**TOWN OF BROOKLYN
PLANNING AND ZONING COMMISSION
Special Meeting Agenda
Tuesday, August 15, 2023 6:30 p.m.**

ENGINEERING SITE PLAN & DRAINAGE REPORT REVIEW

The comments contained herein pertain to my review of a set of plans, consisting of fifteen (15) sheets (sheet 15 architectural missing), entitled "Special Permit Site Development Plan Prepared for Townsend Development Associates, LLC, Providence Road (Route 6), Brooklyn, Connecticut, Dated: May 5, 2023, Revised: N/A," prepared by CHA and Drainage Report, dated May 24, 2023, by CHA.

DRAINAGE PLAN

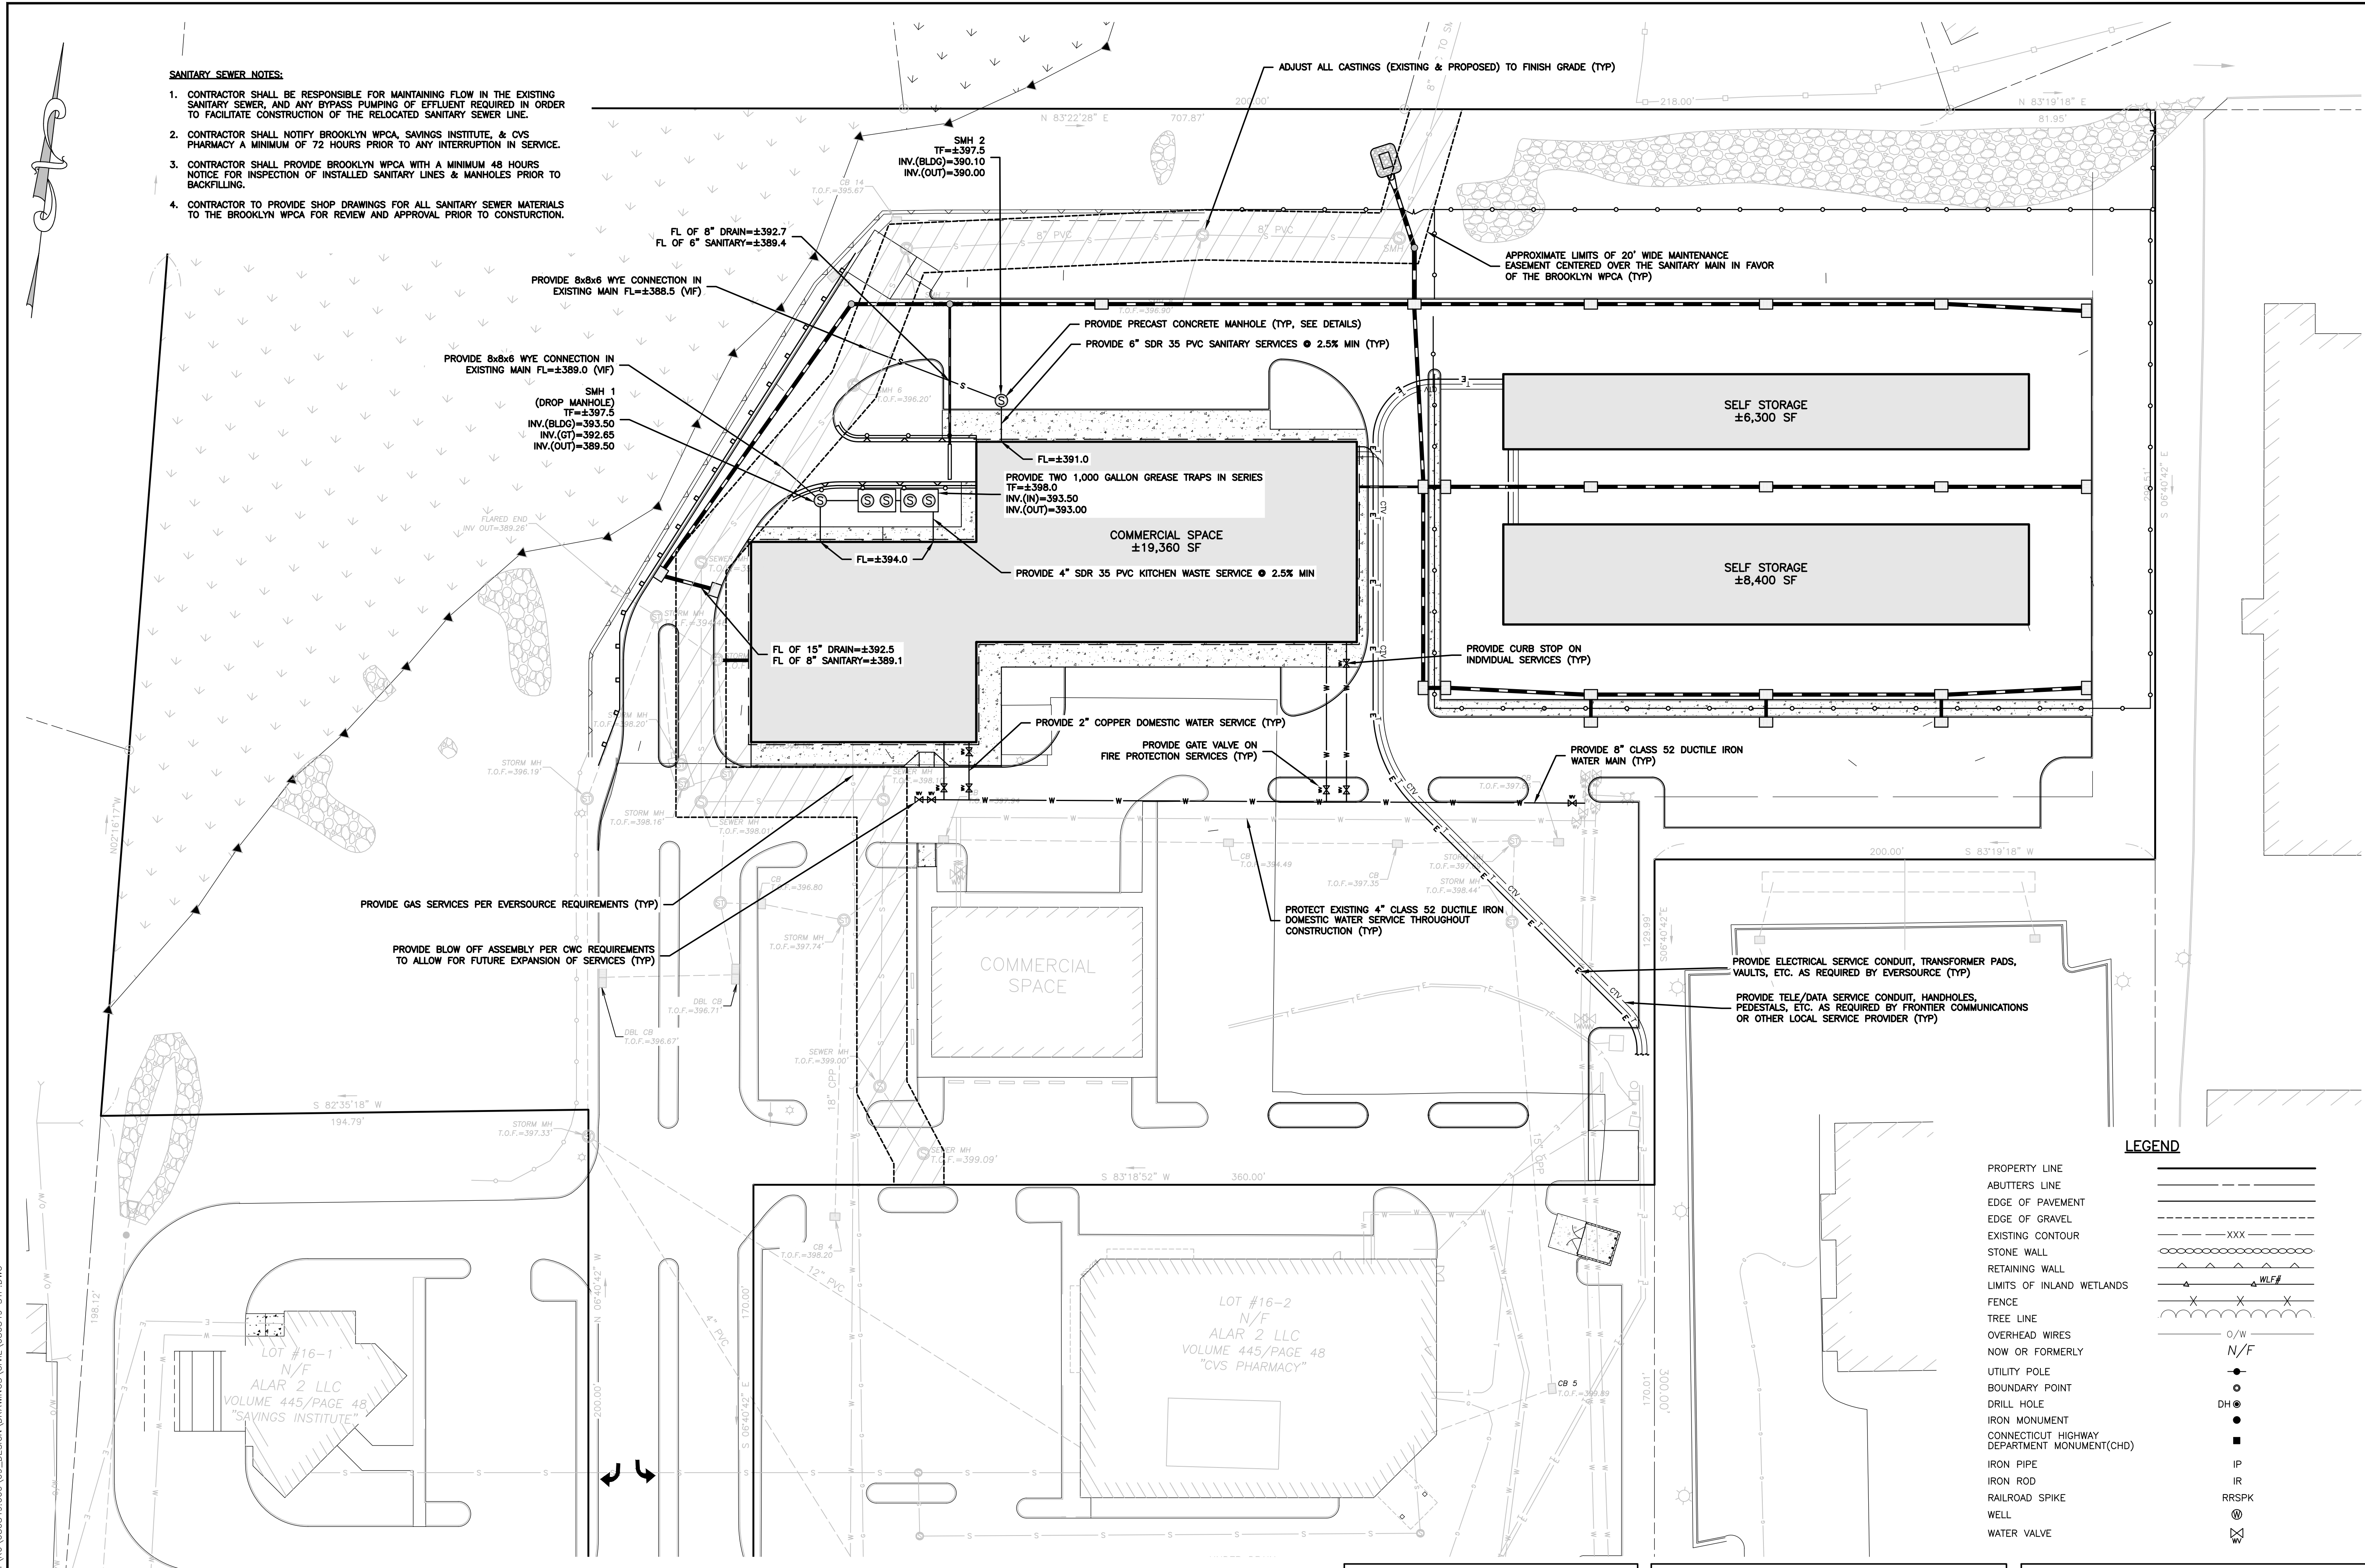
1. Direction of flow arrows need to be included on the plan.
